7 Denmark Street Design + Access Statement

The following pages have been prepared to outline the design developments taken by ICA to no. 7 Denmark Street within Zone 3. The building is a Grade II listed structure and, as such, the strategy developed has been sensitive to the historic nature of the main house and the elements within the yard to the rear.

2.4 Planning history and pre-application feedback

Proposed plans at pre-application stage

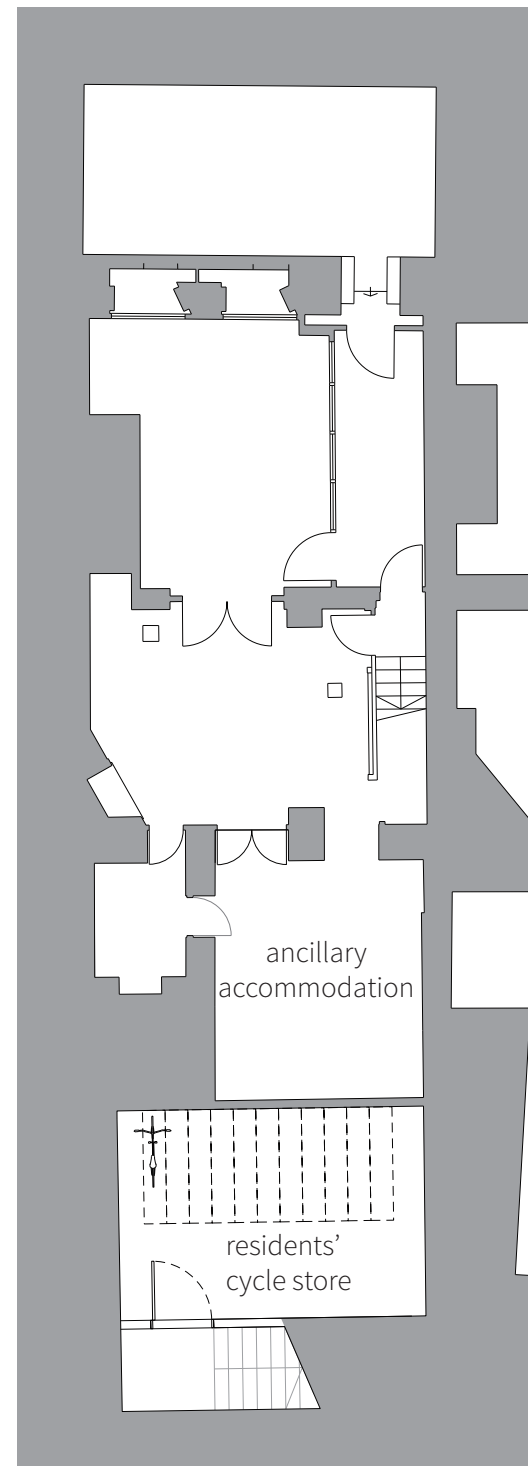
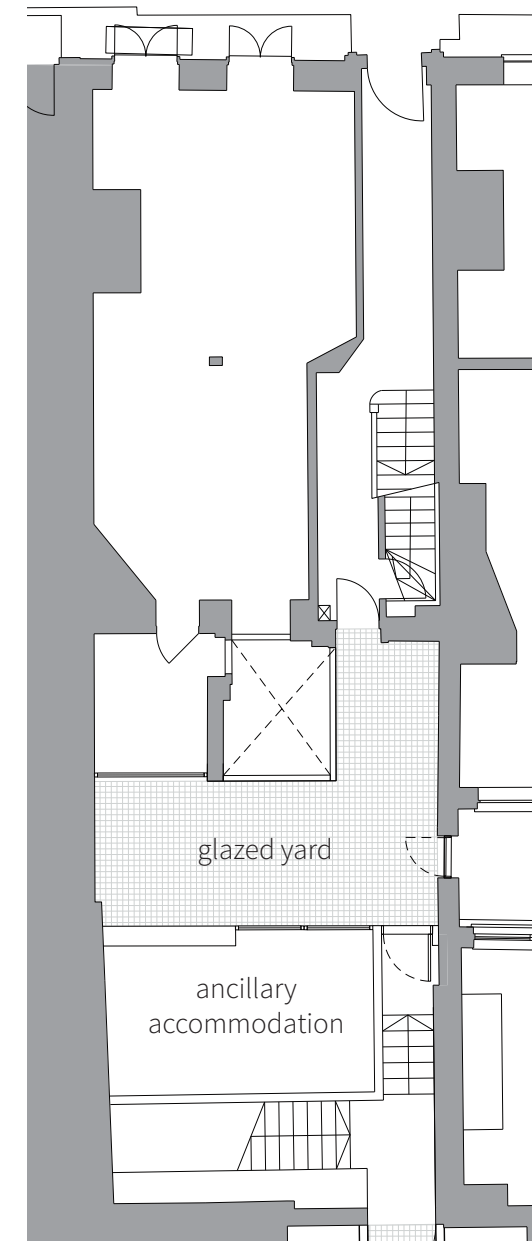
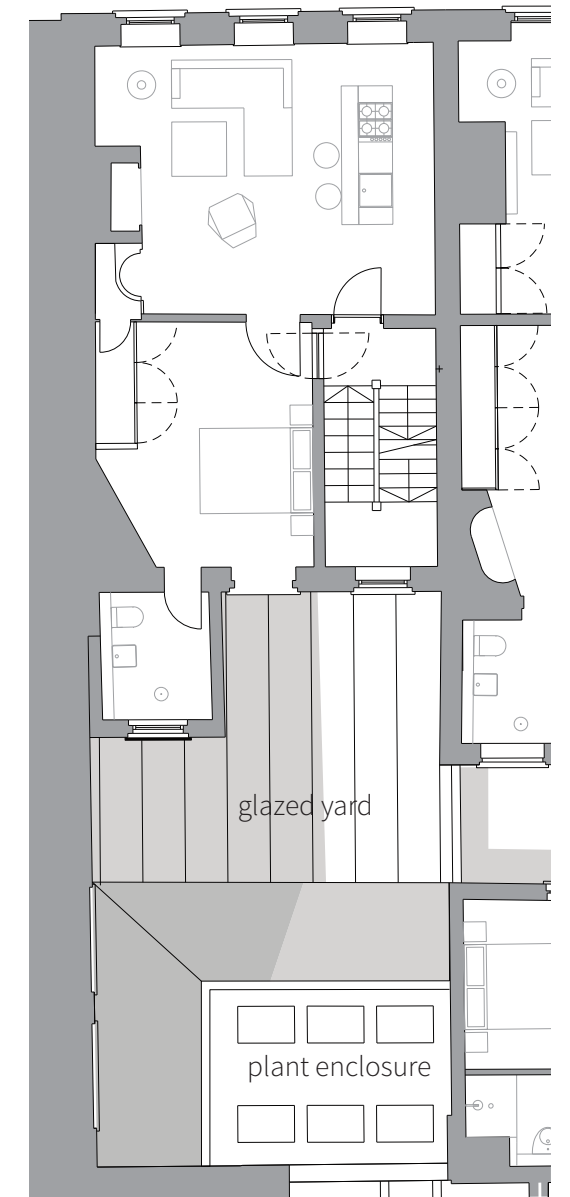
A basement below the garden of no.7 Denmark Street is acceptable in principle as is the proposed bike storage (below ground). However, there is a concern about the extent of original fabric and plan form that would be lost in order to facilitate these aspects of the proposal based on Alan Baxter's schematic dated October 2014 that identifies the building's significance and with annotations dated 11/12/14 that demarcate walls to be removed.

A scheme for a basement under the garden must be able to accommodate these proposals without causing harm to the listed building. In this regard forming an opening in the rear wall to access a new basement compartment is acceptable but complete loss of perimeter walls only retaining a very small opening could not be supported.

It is also noted that the new basement area is a considerable size, occupying a footprint almost as large as the individual rooms in the basement. However, new basement compartments must remain subservient to the main listed building in area, design and detailing as well as being understood and read as modern interventions into the listed building. While this objective is likely more easily achievable for the bike storage that is to be set further back from the listed building, careful consideration is required for the proposed retail space being extended under the garden to achieve the aforementioned objectives.

I also advise that details are necessary about the method of basement excavation and how such works would be carried out without causing harm to the listed building. In addition, in order to make a thorough assessment of basement proposals, details are necessary about whether any structural works are required to the listed building and if so, the resultant implications on its significance.

The proposed link between the main terrace house at no.7 and the garden building is considered to be overdevelopment of the site, affecting the listed building's special interest. It would effectively create full site coverage over the entire plot, not giving a physical or visual break between the listed terrace house and the garden building, and not retaining the hierarchy of spaces or built form. Therefore, development in the rear garden (regardless of it being a glazed link) is not considered acceptable in listed building terms and would not be supported should an application be made for these works (regardless of design or materials).

It is acknowledged that the rear garden structure has suffered some unsympathetic alterations. Some of the proposed works such as retaining the brick chimney and exposing a cast iron stove are welcomed and would better reveal the heritage asset's significance. It is also recognized that some works are likely required to repair and consolidate fabric. However, it is not clear why removal of the building's front elevation is necessary or desirable in listed building terms.

Further, the additional storey shown on the mews building would add further bulk on this modest structure and exacerbate the sense of enclosure in this very confined garden space behind the listed building. The cumulative impact of this addition, with the proposed link covering the entire garden area, and the visible basement development would be harmful to the special interest of the listed building, thereby not being acceptable.

Key concerns raised within the feedback related to the overdevelopment of the site by glazing the mews yard. Another concern related to the loss of historic fabric and in particular the garden structure, including its front elevation. Following the feedback, we have reassessed our approach to the rear mews yard and have developed a strategy that aims to address concerns raised relating to the loss of historic fabric and the impact on the special interest of the listed building.

The size of the basement space linked to the house has been reduced to preserve the hierarchy and legibility of the main house as outlined within the feedback. On the upper floors, the fabric to the mews workshop has been retained, including the front elevation, chimney and fireplace.

The accumulation of elements within the yard space is to be removed and the separation between the main house and the workshop is re-established.
